AGENDA

Architectural Review Board

November 19, 2014

820 East Fairview Avenue

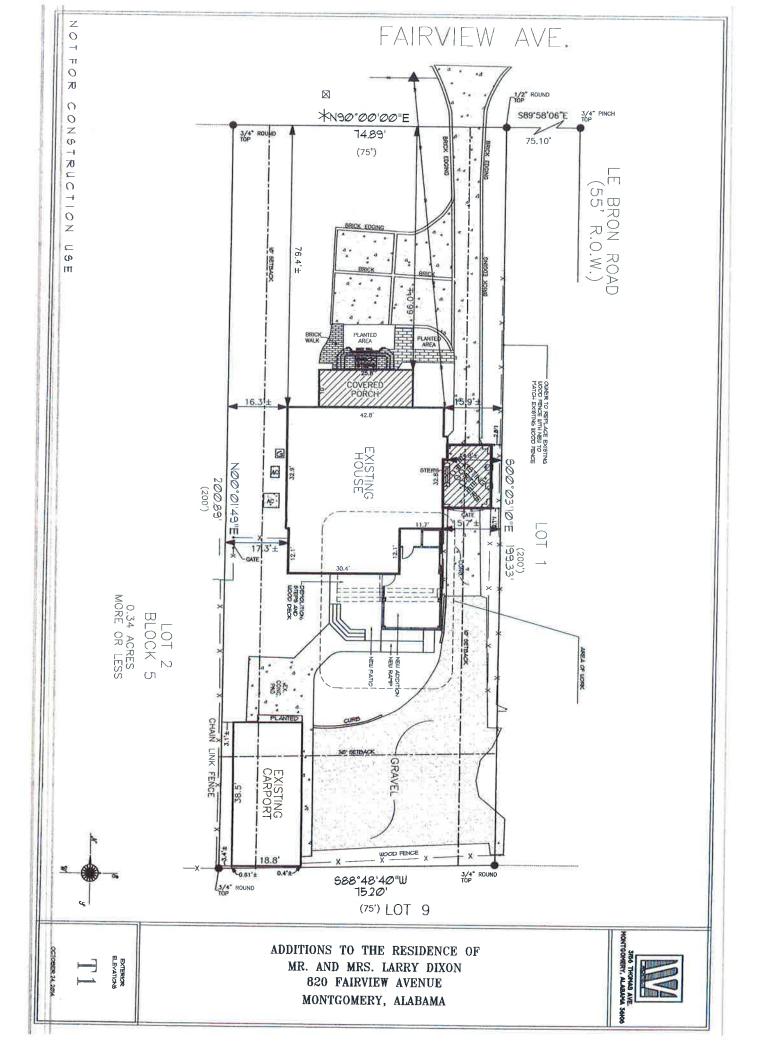
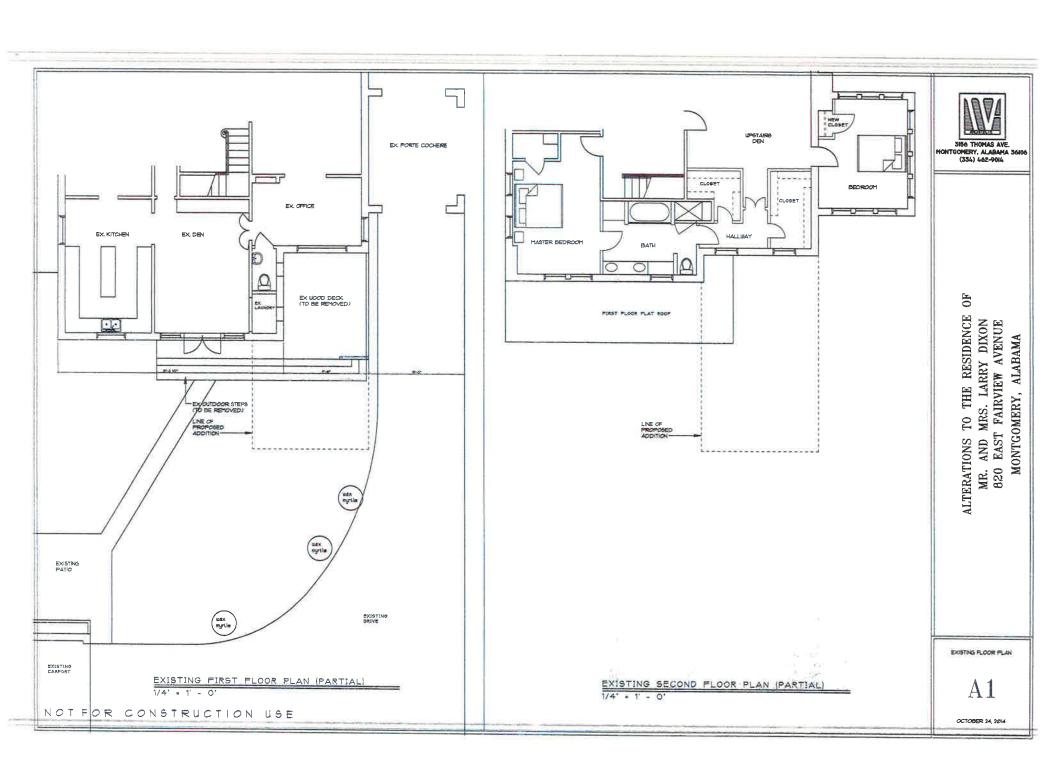
• The extant two story porte cochere will make the addition not visible from Fairview Avenue.

FRONT ELEVATION OPTIONS

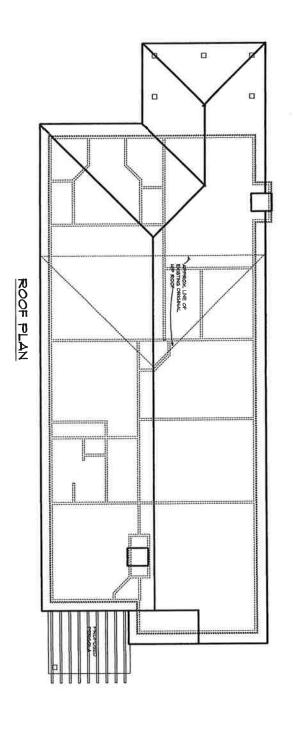
• The tall brick porch piers are a distinctive feature of this house, and staff recommends that detail be retained (and not shortened) with the reopening of the porch.

FLOOR PLAN SCALE: 1/8"=1'

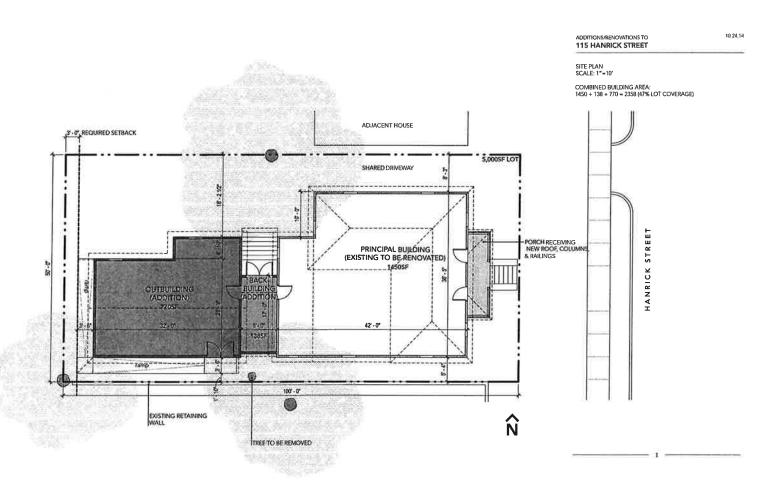
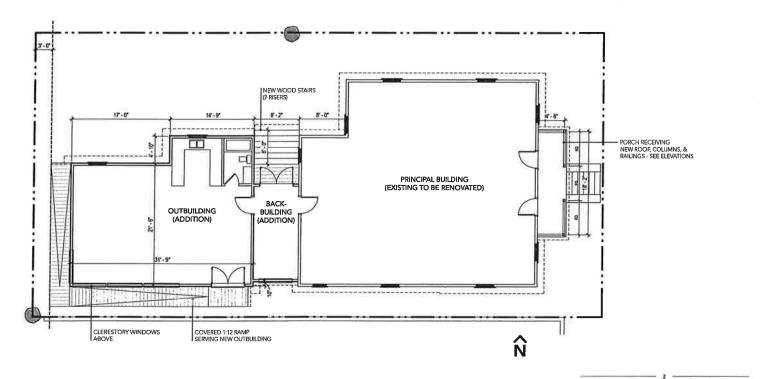
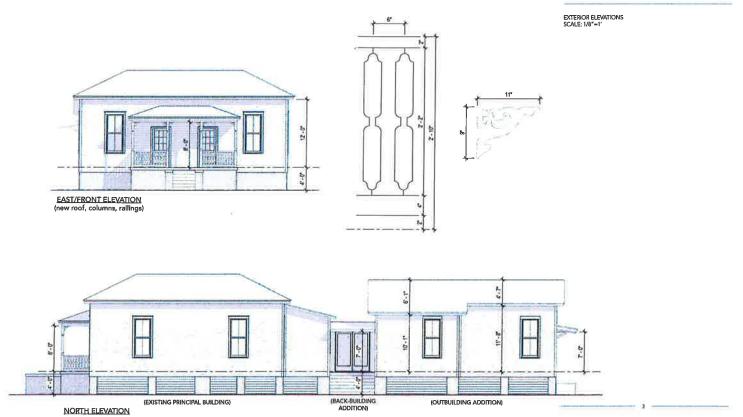
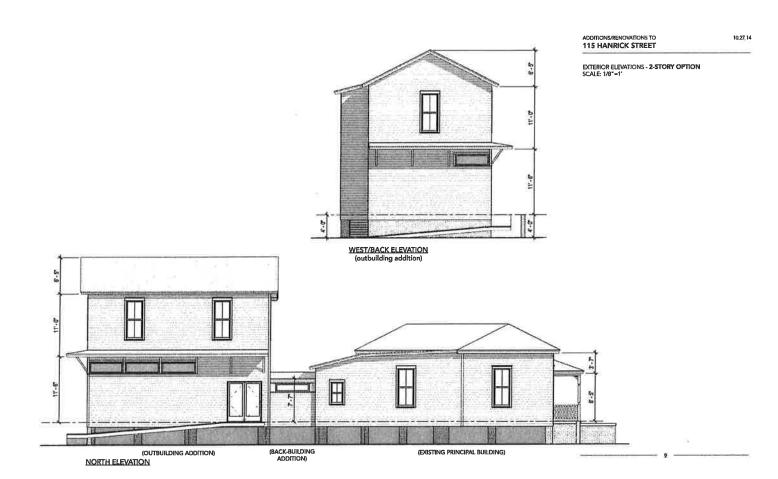
- The Board needs to determine if the size and scale of either addition option is compatible with the single story historic portion of the structure.
- No objection to the tree removal.

2129-A Madison Avenue

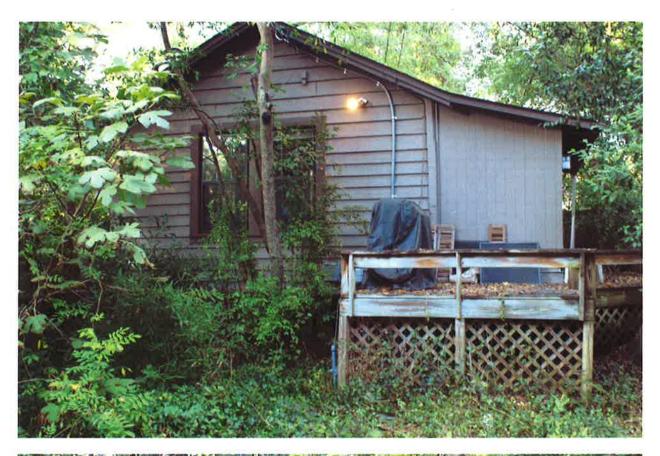
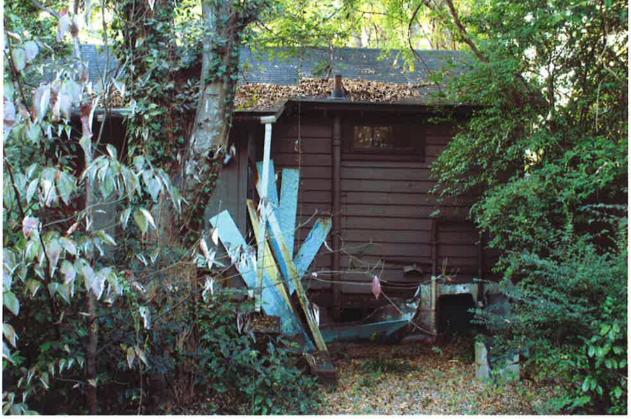
- This building sits at the rear of the lot. Even if the existing gate structure was removed, it would be difficult to view from the street.
- The building does not appear on the Sanborn maps, but the county records indicate it may be from 1920.
- The Board needs to determine if the proposed door and window changes are appropriate.
